Demolition Management Plan

156 West End Lane, West Hampstead

Planning Reference: 2015/6455/P

**Phase 3 DMP: Revision 4 –
dated 17th February 2021**

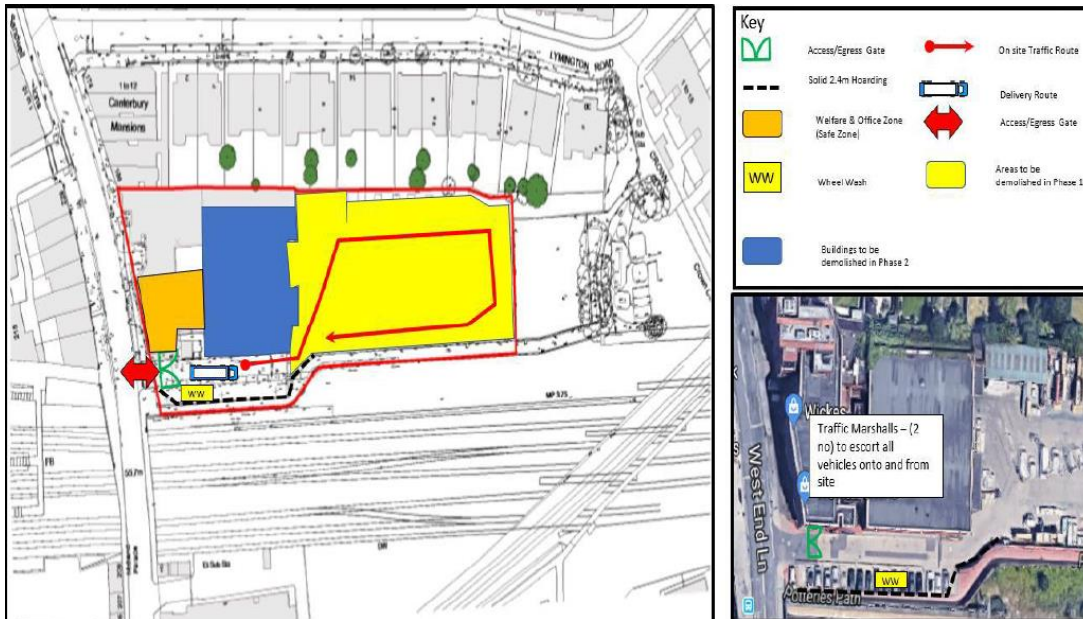
The site consists of a former builder's merchant yard and it is proposed that the site will accommodate all waiting time within the site boundary. The site plan below demonstrates this on-site strategy:

All vehicles will access and egress site directly from West End Lane. This is shown in the above location map. Two number traffic marshals will escort vehicles from the site onto the public highway; and provide safe crossing for pedestrians.
